Staff Report to the Zoning Administrator

Application Number: **07-0449**

Project Description: Proposal to demolish an existing single family residence and construct a replacement 2-story single family residence. Requires a Coastal Development Permit, a Variance to increase the height limit from 17 feet to 21 feet, a Variance for two stories on the beach side of Beach Drive (RB zone district limits the number of stories to one on the beach side), and a Residential Development Permit for a wall between 3 and 6 feet in height within the required ten foot front yard setback.

View from Beach Drive

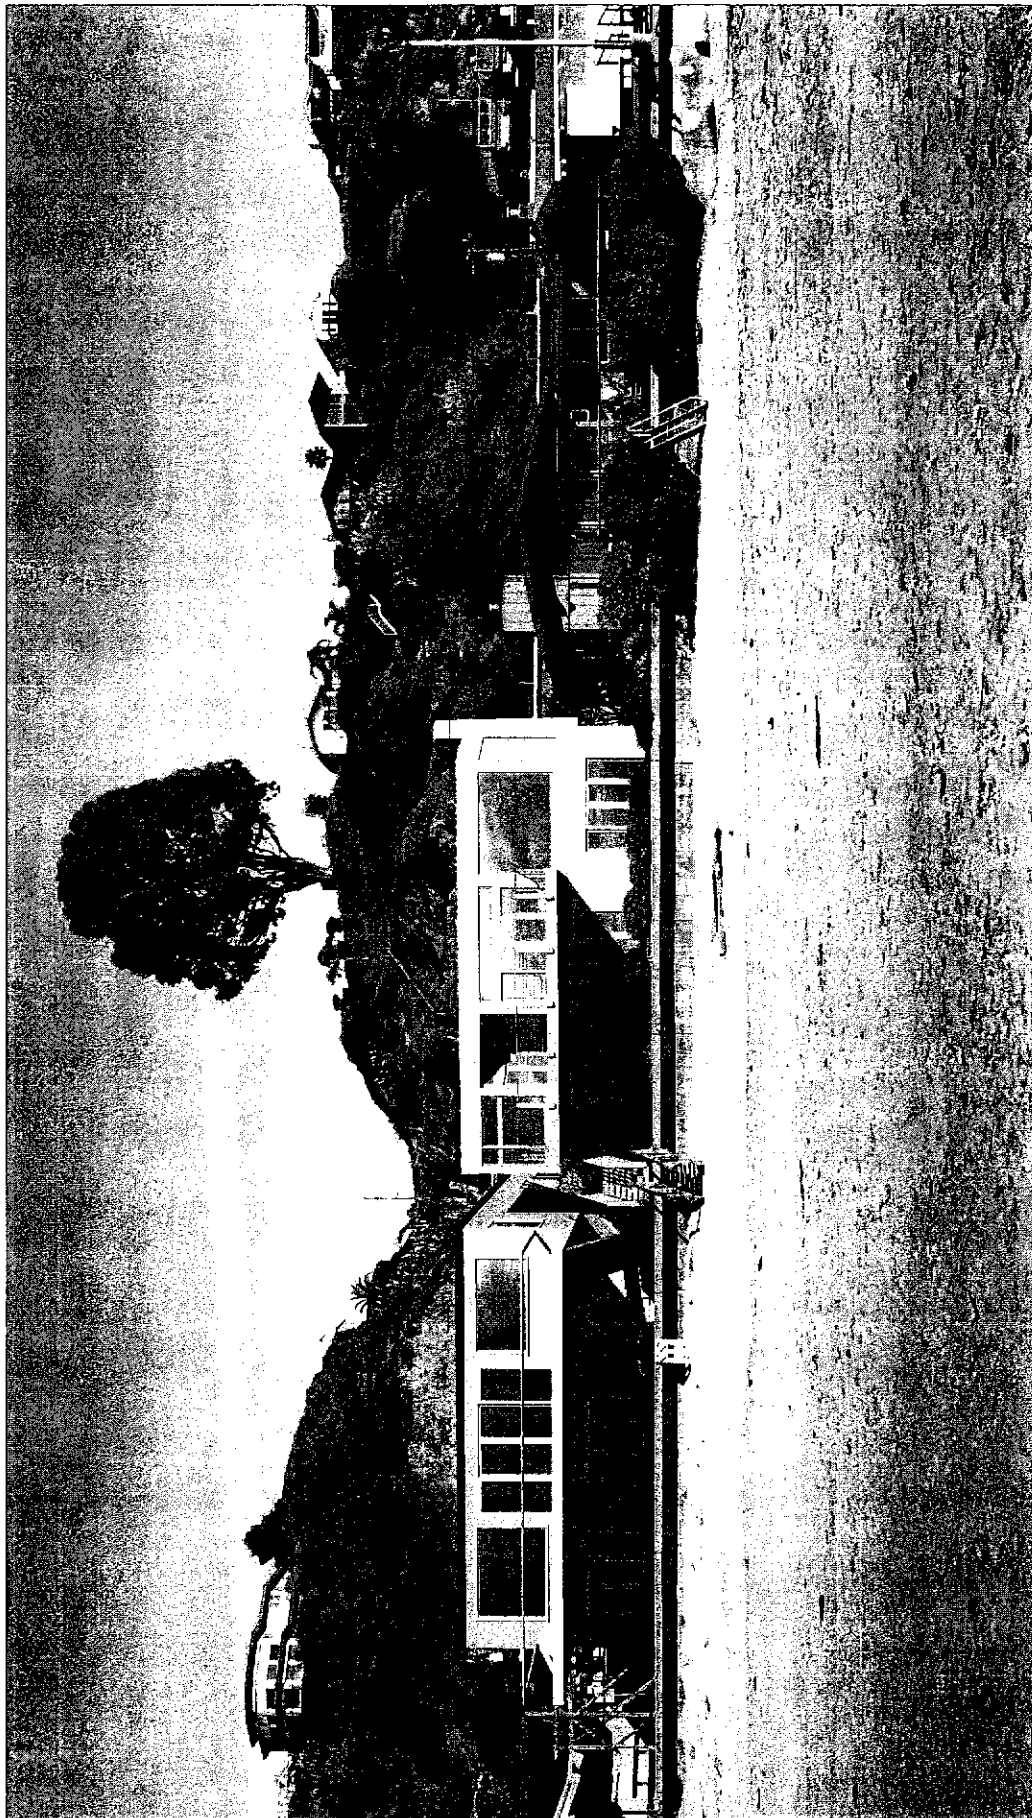
This finding can not be made, in that the location of the proposed fence will not be compatible with the visual neighborhood character of the surrounding neighborhood in which there are no other fences greater than three feet in height front along the roadside in the vicinity. The fence is an allowed ancillary use in the RB zone district as the primary use of the property will be residential, however, it must be no more than three feet tall within the front yard setback or up to six feet tall outside of the front yard setback. A condition of approval has been included that requires the plans be revised to lower the wall to three feet within the front yard setback or move it back, outside of the front yard setback

This finding can not be made for the proposed fence and gate, in that the proposed fence will not be compatible with the visual character of the neighborhood due to its height, design, and location as fences or walls over three feet within the front yard setback are not common on Beach Drive. A condition has been included to revise the plans to include a fence of similar height and design outside of the ten foot front yard setback, or one of no more than three feet in height within the front yard setback.

4. Revise plans to lower the wall to three feet within the front yard setback or move it back, outside of the front yard setback.
